Local Planning Panel 10 August 2022

Address: 25-27 Dunning Avenue, Rosebery

D/2021/1491

Alterations and additions to heritage warehouse building to create a five storey commercial development

FSR

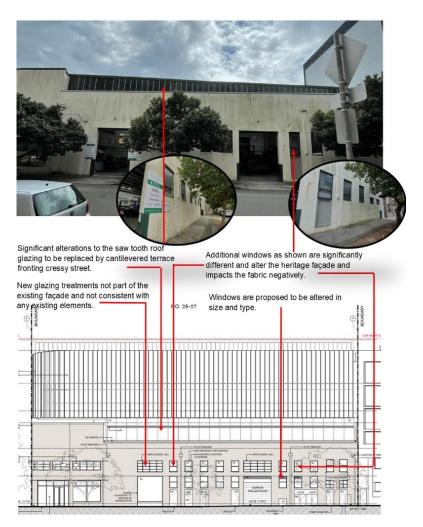
- Proposed FSR 3.1:1 (2,966sqm)
- Control Max 2.3:1 base FSR 1.5:1, community infrastructure bonus 0.5:1, end of trip facilities up to 0.3:1
- The proposed bonus FSR of 0.5:1 is not supported as does not meet objectives of controls
- The proposed end of journey FSR is 0.076:1 (73sqm) which is accepted
- The 4.6 variation is based on the base FSR and is requesting 107% variation to the standard.

Impacts on adjacent development

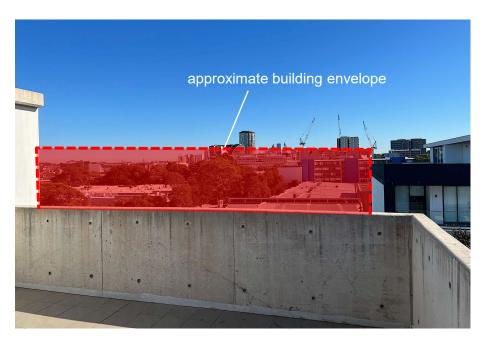
- View loss issues were raised in submissions
- A proposal with reduced FSR would facilitate reduced impacts
